J. A. McDONALD, INC.

CLARENDON BRO 1443(48)
BRIDGE #11
ERECTION PLAN
Supplement to Address Review Comments Dated 6/15/16

LIFT LOOP DESIGN CALCULATIONS

SUPPLEMENT #1

SK-7

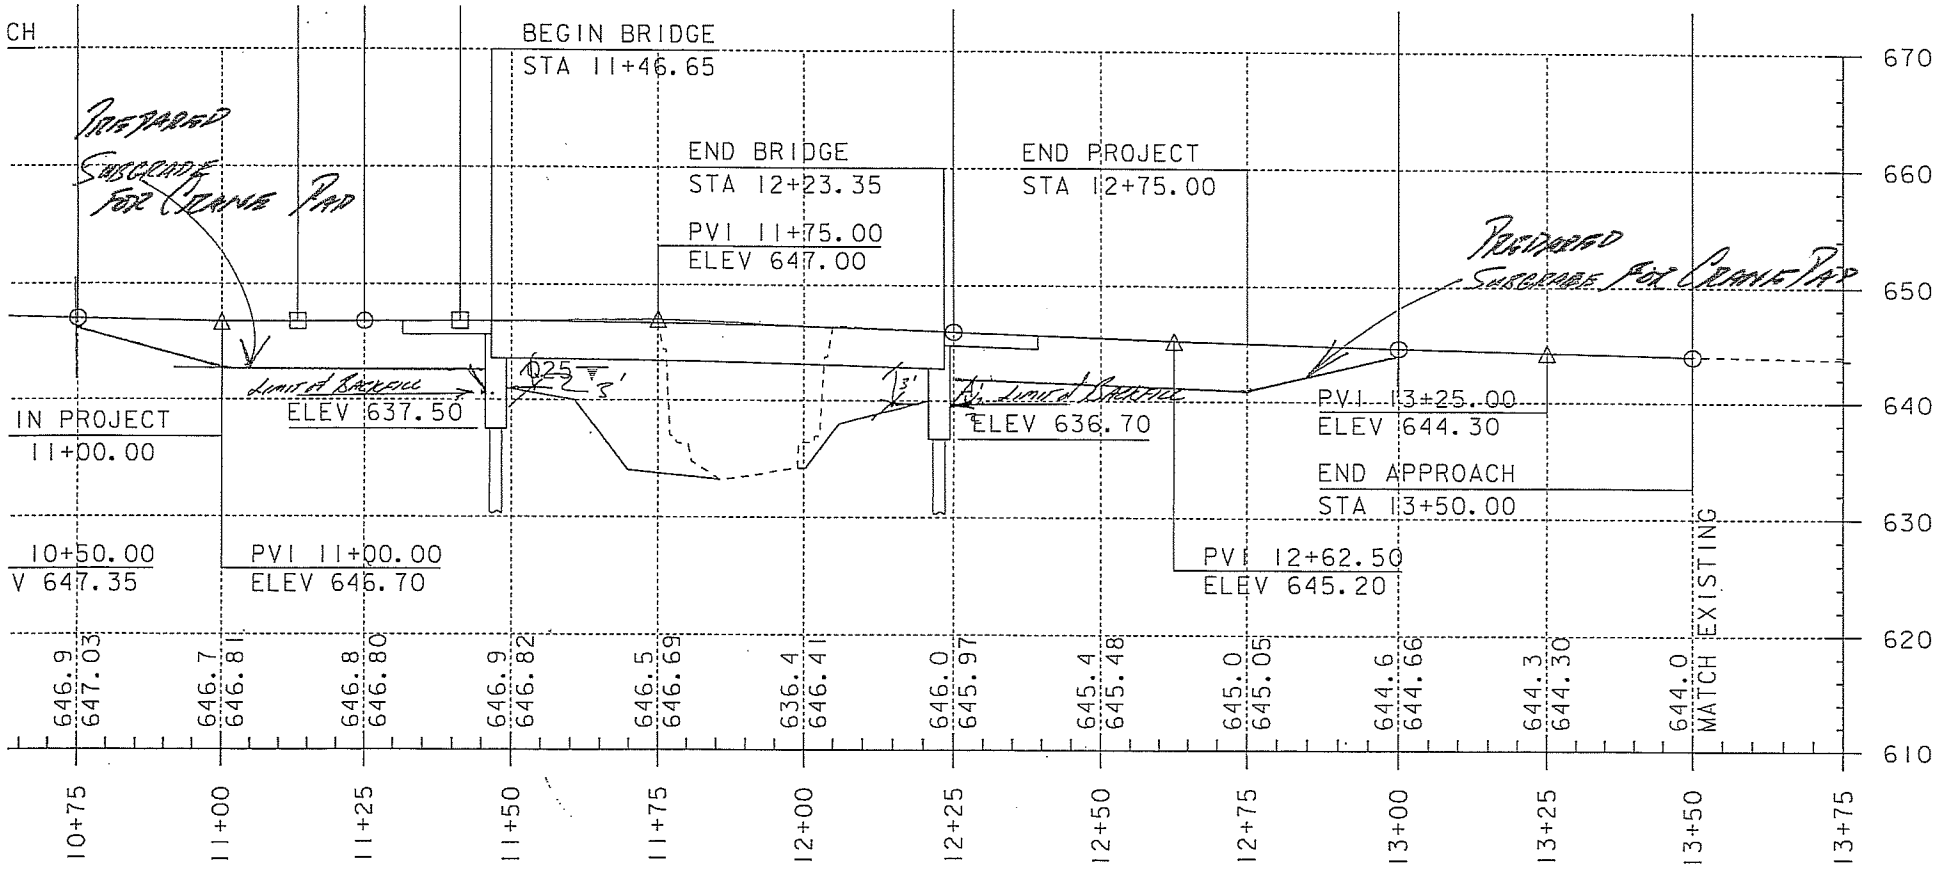
- *Per Contract Plans General Note 43 on Sheet 3/59, backfill shall be limited to the height of 3' below the bridge seat elevaction of the NEXT beams. This needs to be clear in the plan.* JA McDonald incorporates into its Erection Plan General Note 43 found on Sheet 3 of 59 which states: "The backfill behind the abutments shall be limited to a height of 3'-0" below the bridge seat and no cranes shall be closer than 1'-0" to the abutment during the erection of the superstructure" See attached Sketch SK-7

See General Note #43
Sheet 3 of 57

43. THE BACKFILL BEHIND THE ABUTMENTS SHALL BE LIMITED TO A HEIGHT OF 3'-0" BELOW THE BRIDGE SEAT AND NO CRANES SHALL BE CLOSER THAN 1'-0" TO THE ABUTMENT DURING THE ERECTION OF THE SUPERSTRUCTURE.

C-AB1 Abutment Elevation Schematic

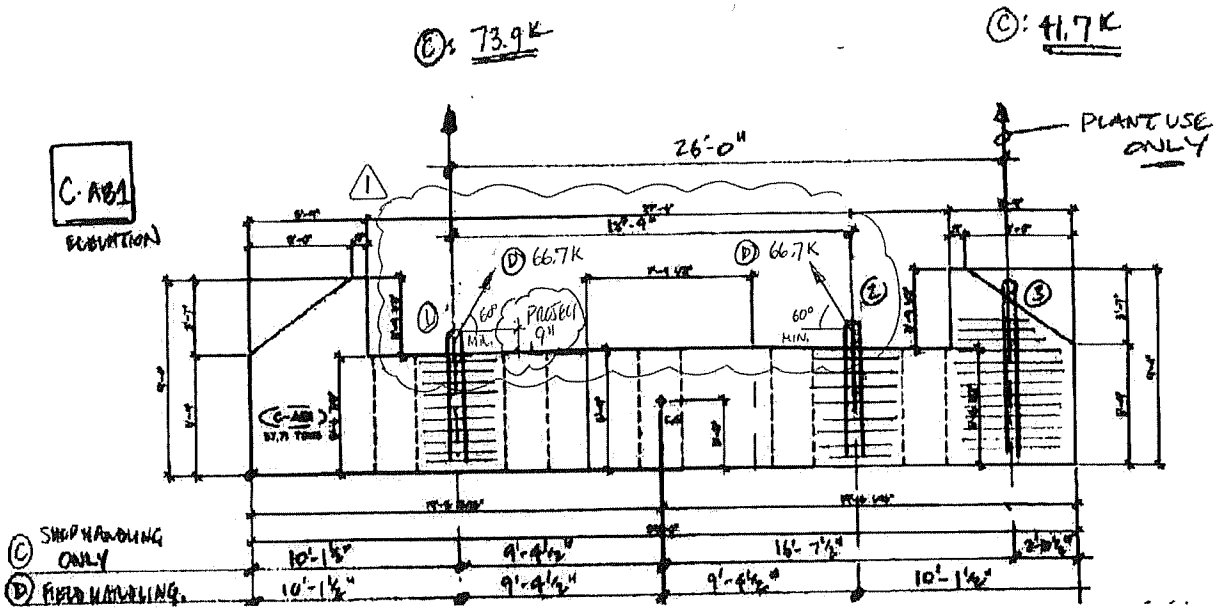
- *Abutment General Note #5 on Sheet C1 of the approved fabrication drawings states that vertical forces are to be applied to the lifting loops. The fabricator's lifting loop design for the abutments does not appear to account for horizontal lifting forces. If sling angles less than 90 degrees to the horizontal are required, provide documentation from the fabricator that this is acceptable with supporting design calculations stamped by a PE if necessary.* See attached documentation.

Install (3) sets of (2) Lift Loops consisting of (4) 0.6" diameter 270 ksi prestressing strands each, with minimum 5'0" embedment and projection above cheek walls. In plant use lift loops at location 1 & 3 with lift plate A or B at location 1 and (3) 25-ton cranes. In field use lift loops at location 1 & 2.

1 ORIGINAL $R_1 = R_2 = 57.8K$

$R_{1-60°} = R_{2-60°} = 57.8/0.866 = 66.7K$ EA (2) LOOPS
